STERLING RANCH FILING 4

GRADING AND EROSION CONTROL PLANS

NOVEMBER 2022
PCD FILING NO. : SP-22-030

STERLING RANCH FILING 4
COVER SHEET

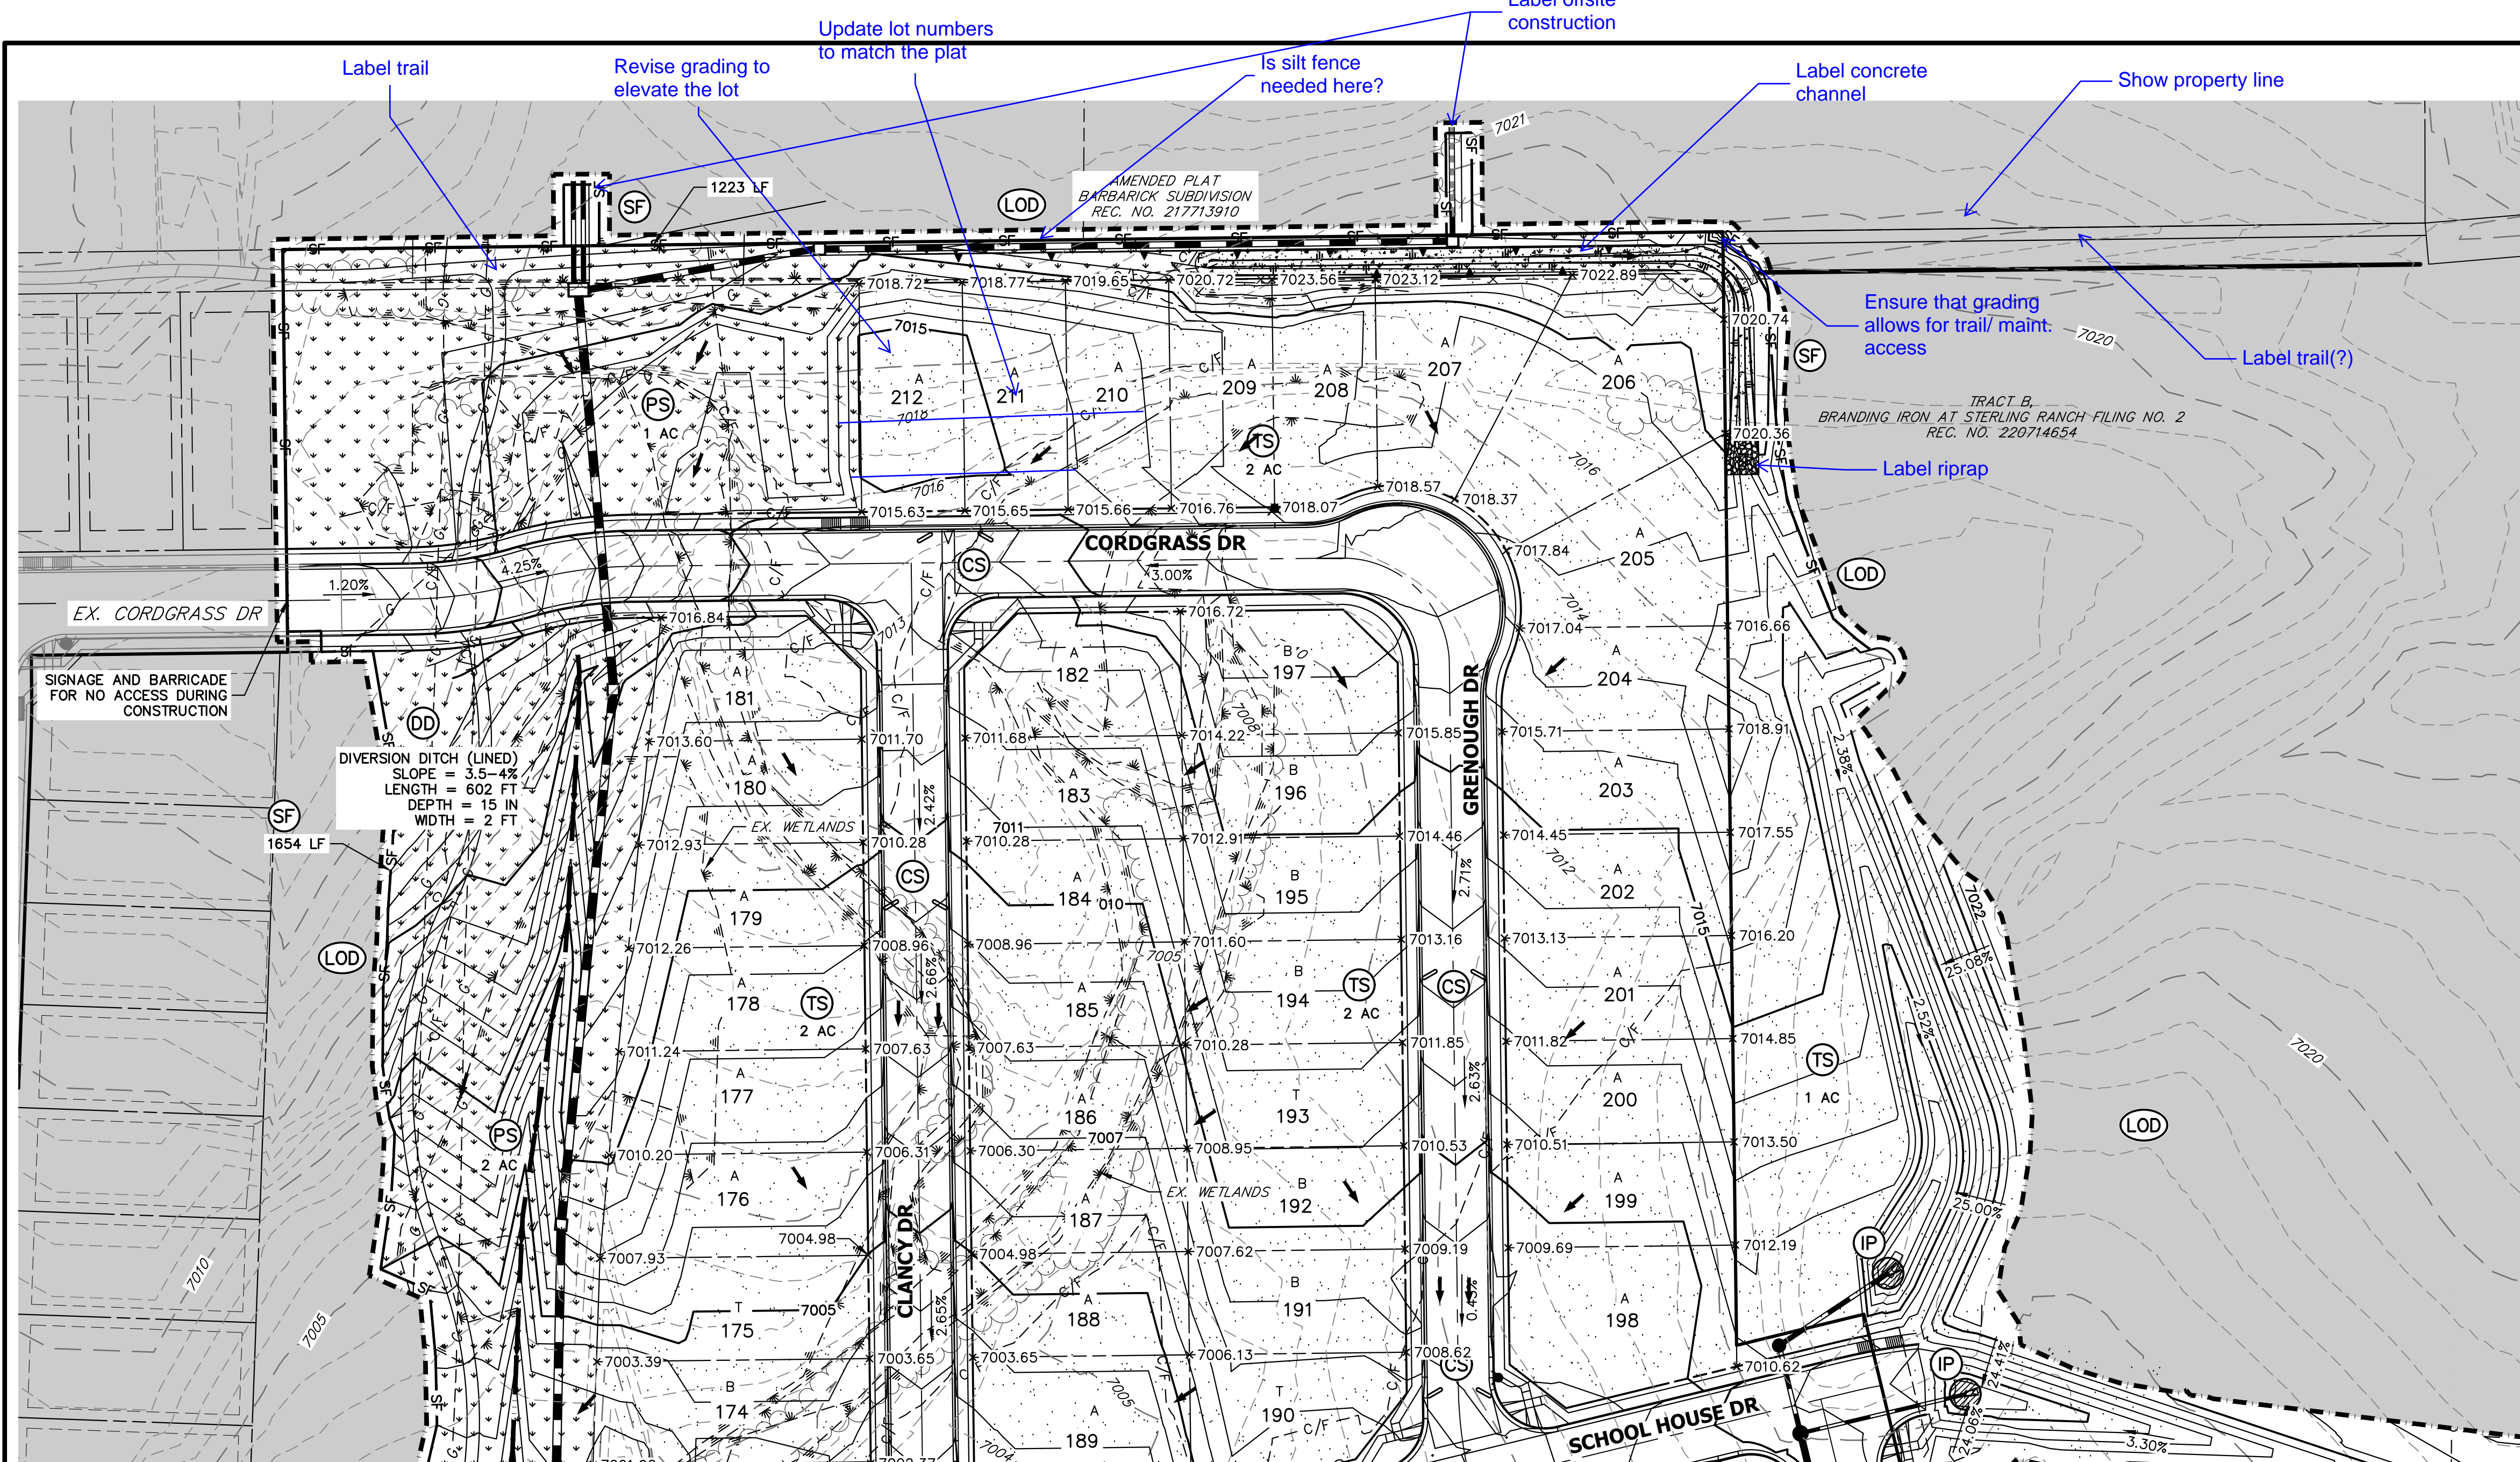
Should be "SF" not SP

GRADING & EROSION CONTROL PLAN

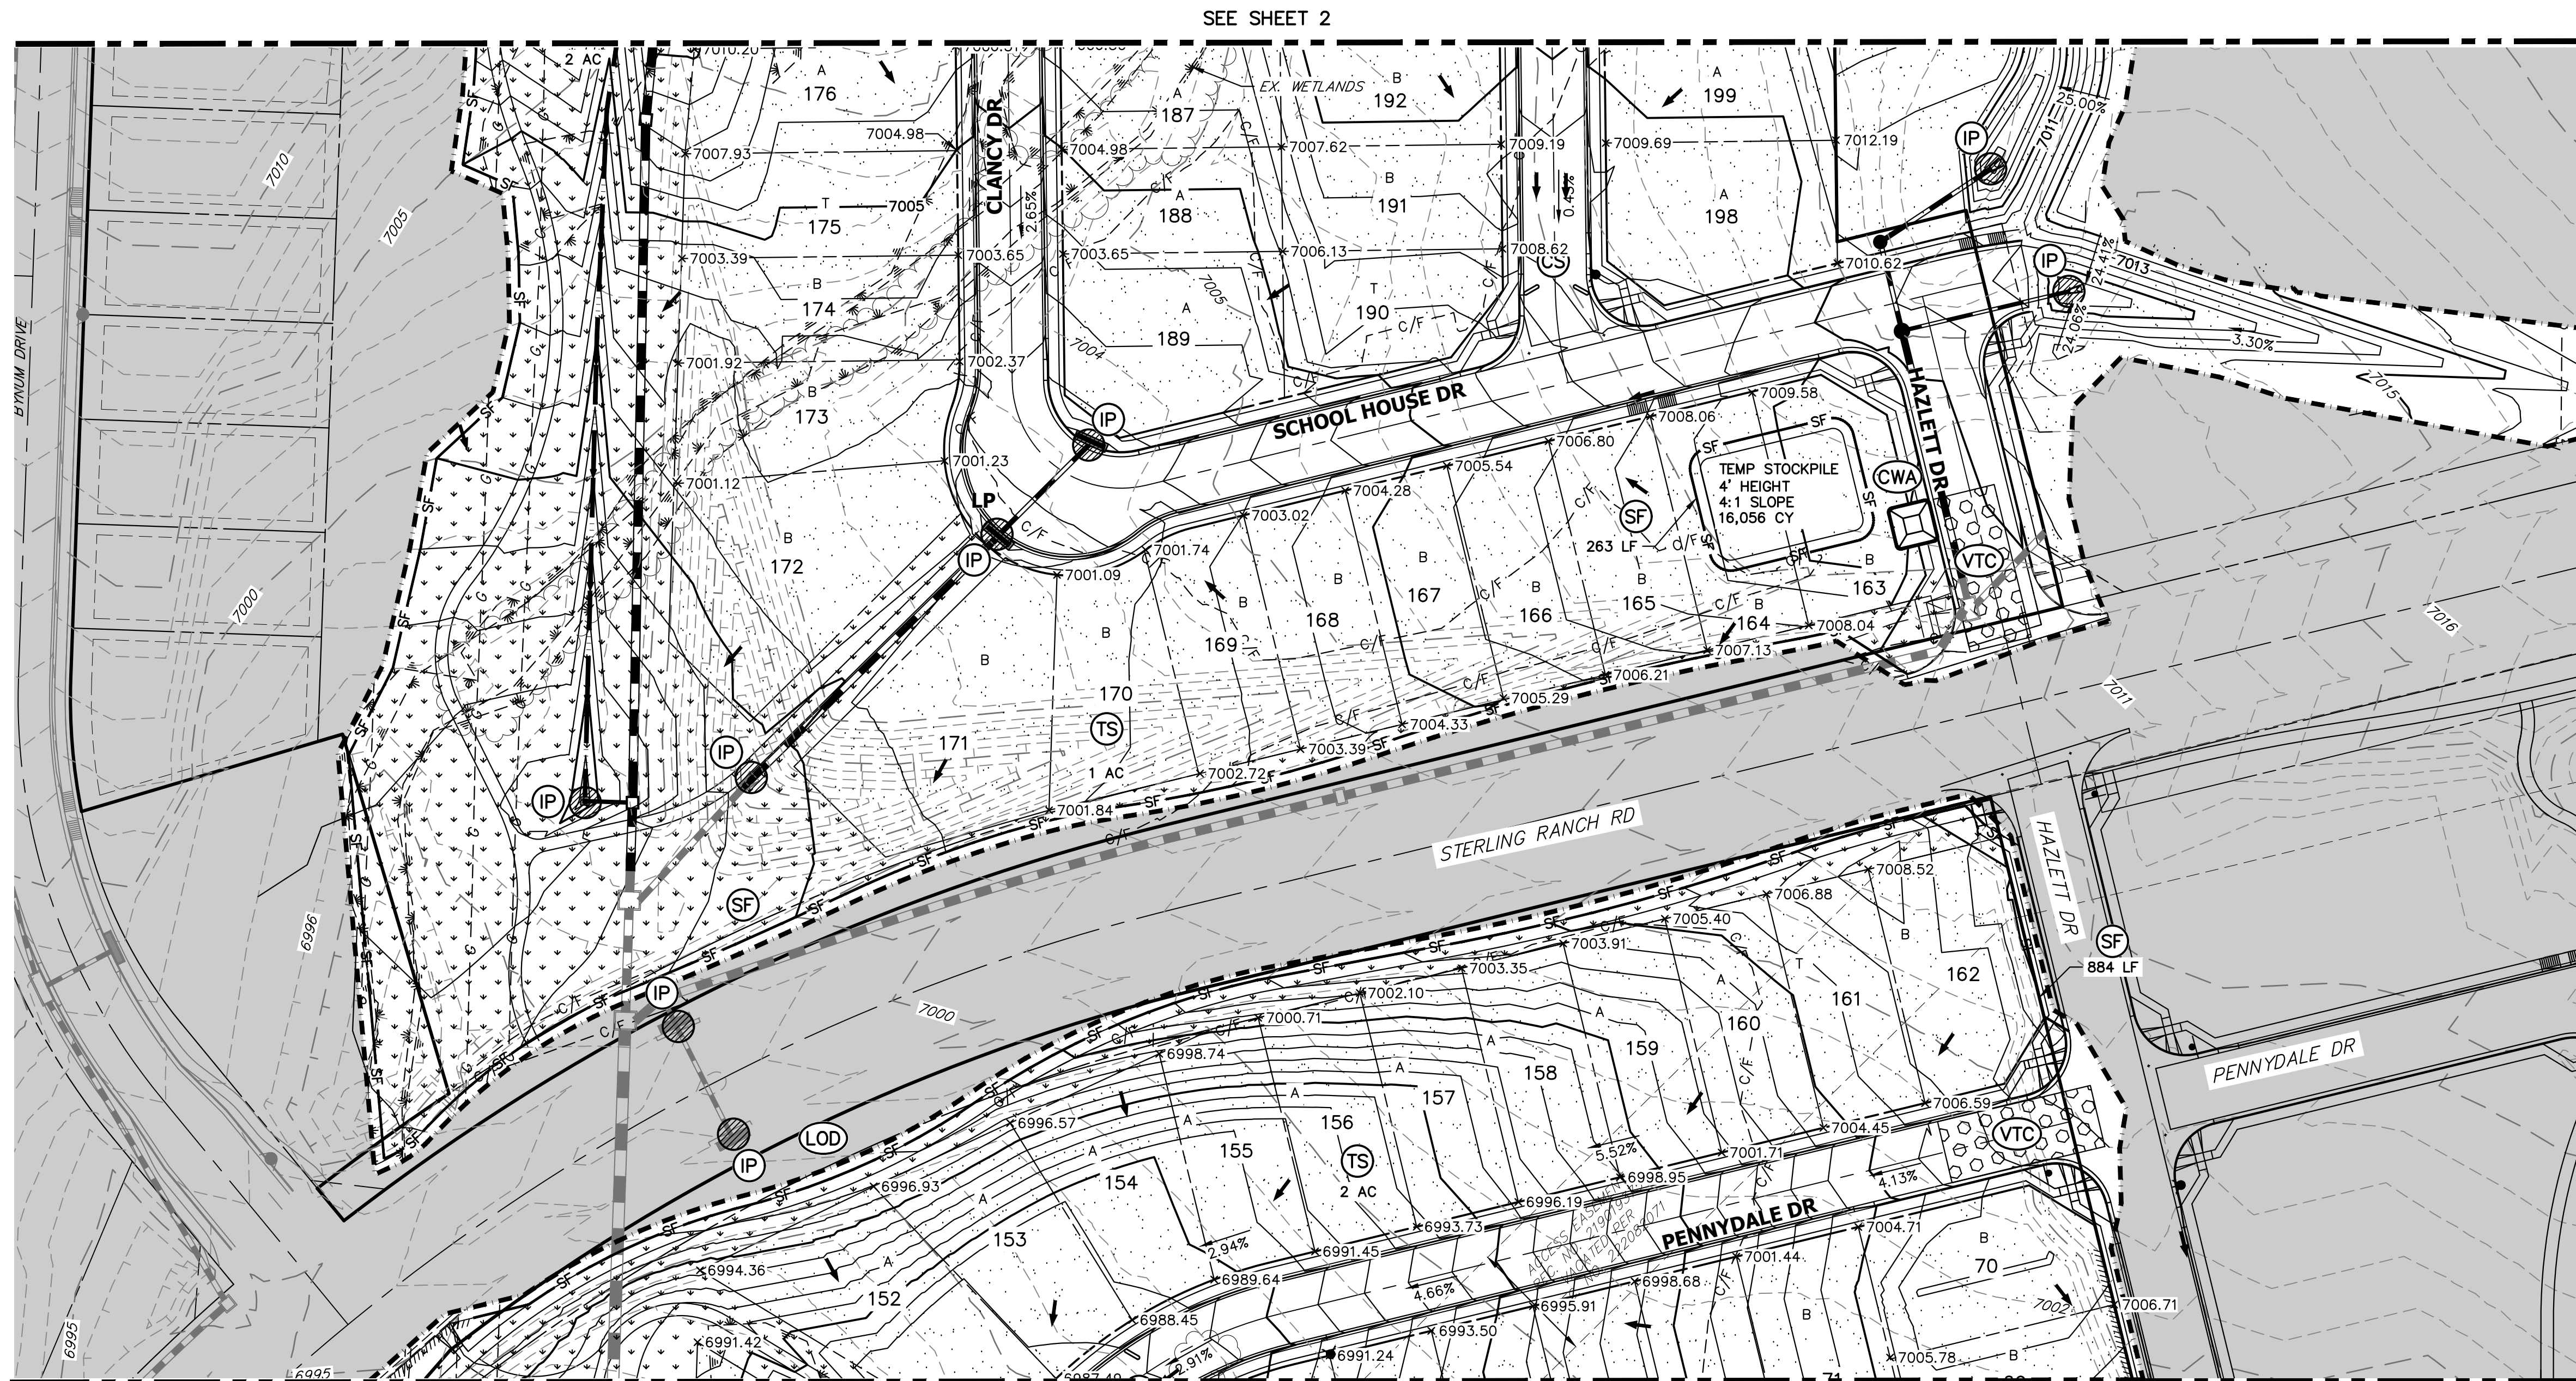
Provide trail/maint. access road cross-section

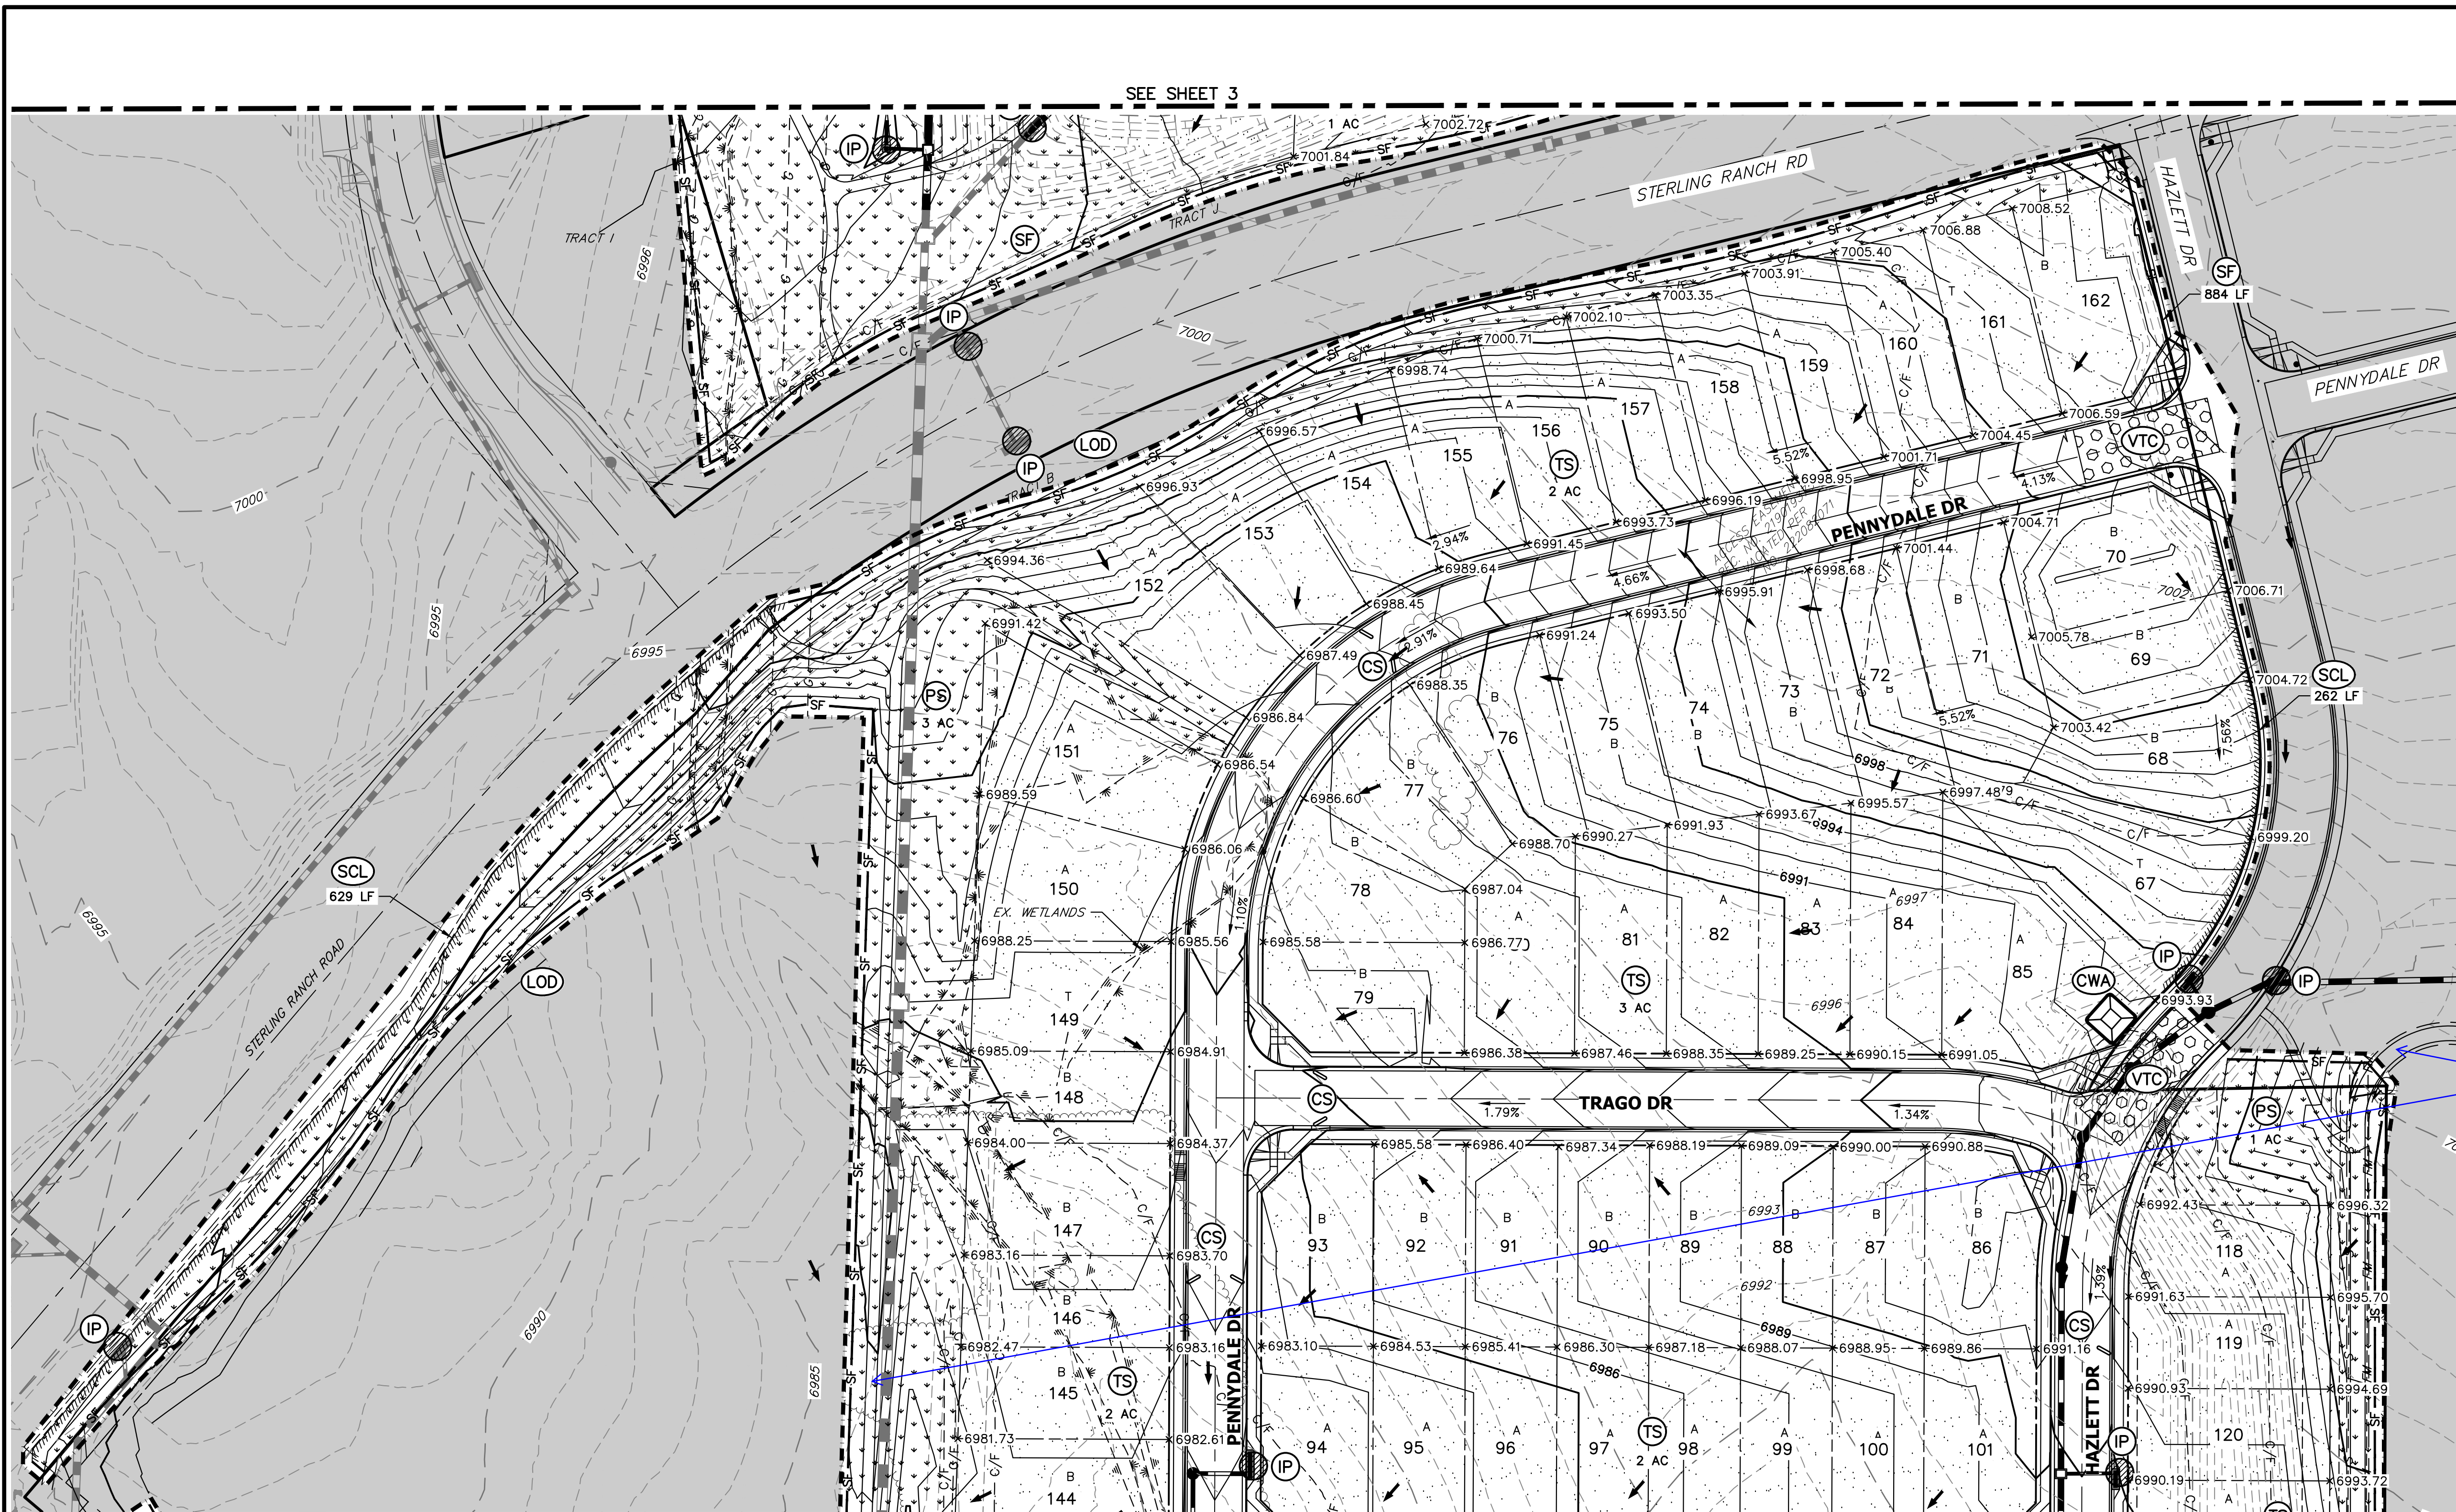
This grading is different from the previous submittal. Move the viewport limits over to the right to include entire limits of proposed grading area.
